PROPOSED AMENDMENT REQUEST TO THE FSV  
PPS TECHNICAL SPECIFICATION

Attachment 2  
P-88025  
Page 2  
February 8, 1988

SUMMARY OF PROPOSED CHANGES

PROPOSED CHANGES TO LSSS 3.3 AND LCO 4.4.1  
OF THE FSV TECHNICAL SPECIFICATIONS

FIGURE 3.3-1

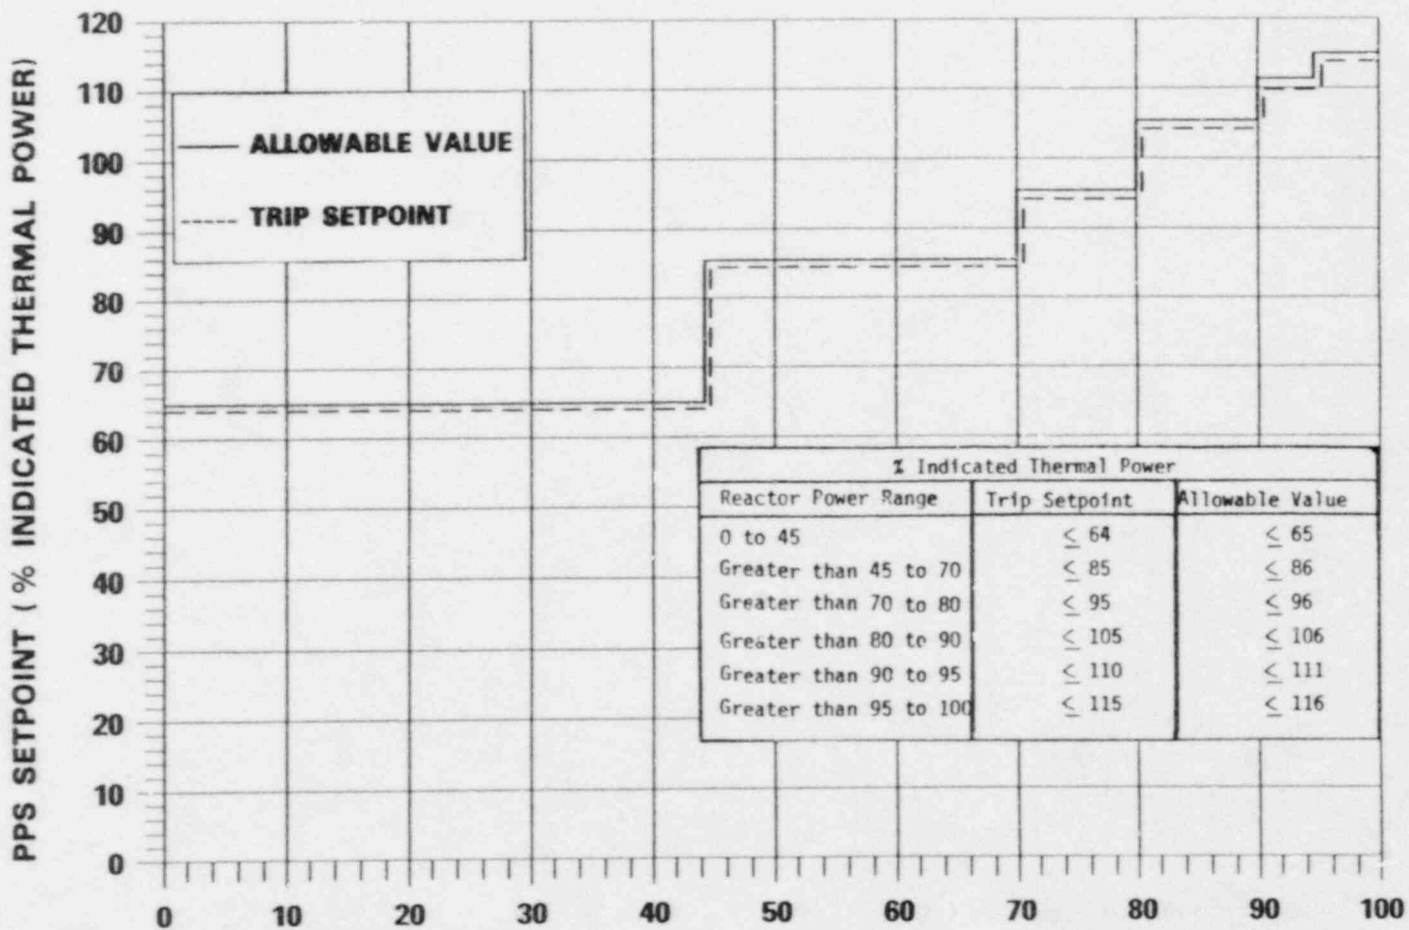
PARAMETER	FUNCTION	TRIP SETPOINT	ALLOWABLE VALUE
1. Reactor Core Limiting Safety System Settings			
a) Linear Channel-High (Neutron Flux)	Scram	Varies as a function of Indicated Thermal Power per Figure 3.3-1	varies as a function of Indicated Thermal Power per Figure 3.3-1
b) Reheat Steam Temperature-High	Scram	< 1055 degree F	< 1067 degree F
c) Primary Coolant Pressure-Programmed Low	Scram	< 68.6 psi below normal, programmed with Circulator Inlet Temperature. Upper TRIP SETPOINT of $\geq 631.1$ psia.	< 72.7 psi below normal, programmed with Circulator Inlet Temperature per Figure 3.3-2. Upper limit to produce trip at $\geq 627$ psia.

HIGH NEUTRON FLUX SCRAM  
 DETECTOR DECALIBRATION  
 CURVES FOR CYCLE 4

FIGURE 3.3-2

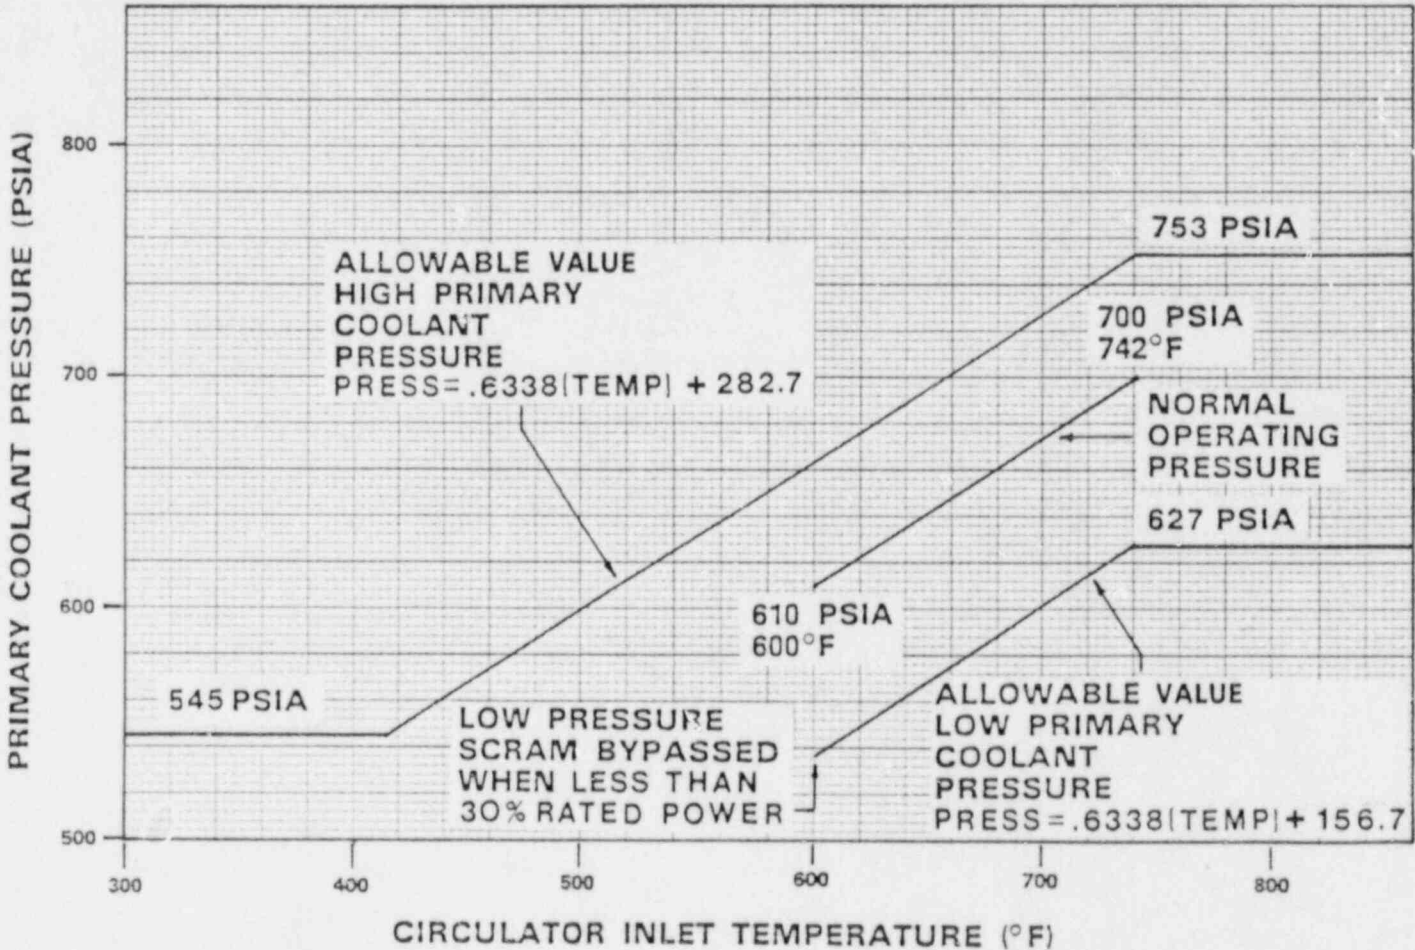
PRIMARY COOLANT PRESSURE vs. CIRCULATOR INLET TEMPERATURE  
 ALLOWABLE OPERATION
